GROUP	MODEL
CLI	2021-2022MY K5 (DL3a)
NUMBER	DATE
056	August 2024

TECHNICAL SERVICE BULLETIN

HEATING, VENTILATION, AND AIR CONDITIONING (HVAC) SUBJECT: BLOWER MOTOR FUSE RELOCATION (WTY037)

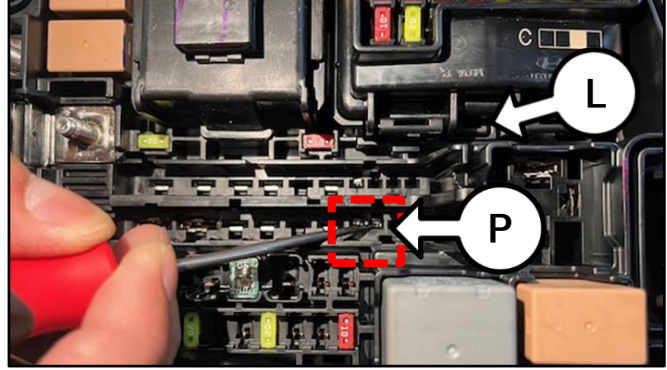
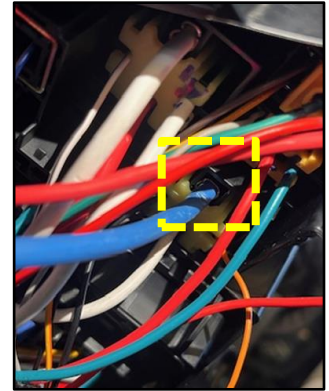
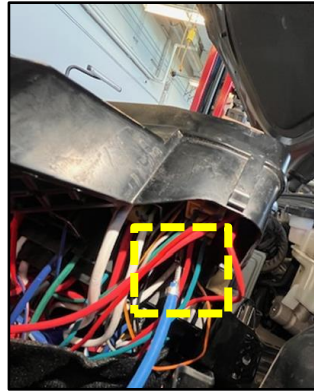
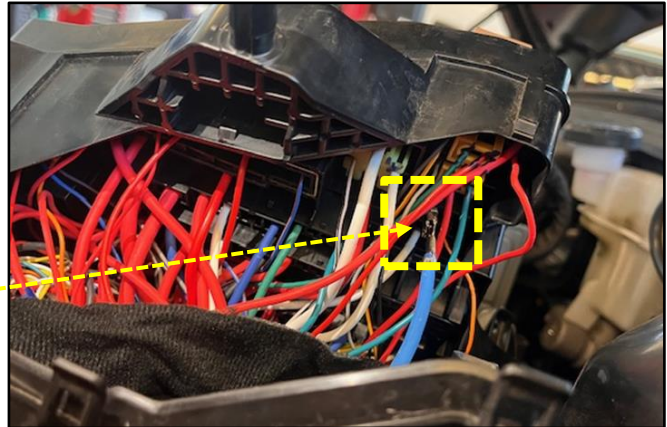
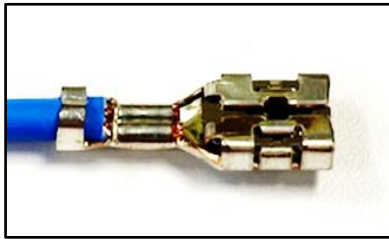
13. Using a pick/awl, disengage the wiring pin (P) release tab from the multi-fuse (K) #3 position on the junction block (L).

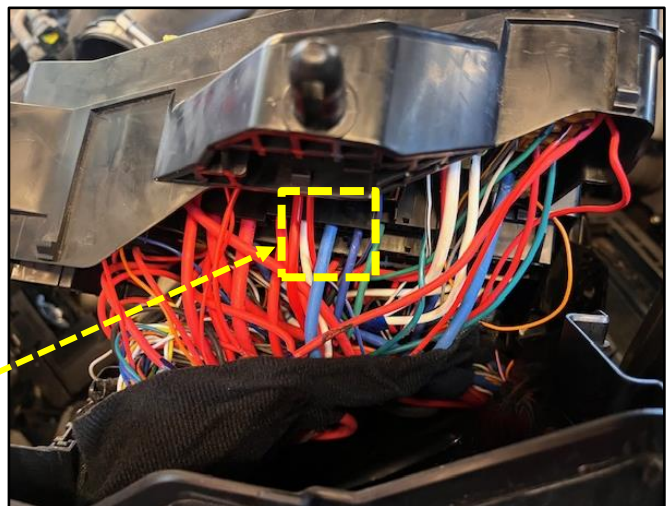
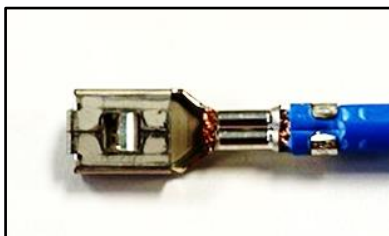
14. Install one end of the new wire in the blower motor relay (I) position on the junction block (L), as shown.

15. Insert the other end of the new wire in the multi-fuse (K) #6 position on the junction block (L), as shown.

Note: Ensure that the new wire is secured behind the fabric tape, as shown.

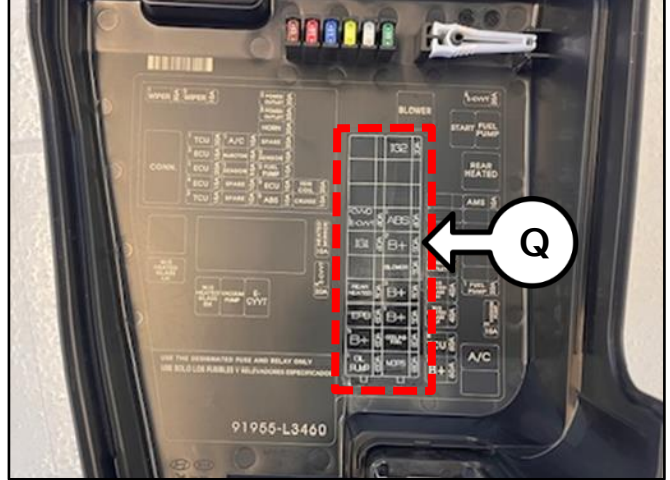
16. Install new junction box fuse cover label (Q) on the junction box fuse cover (H).
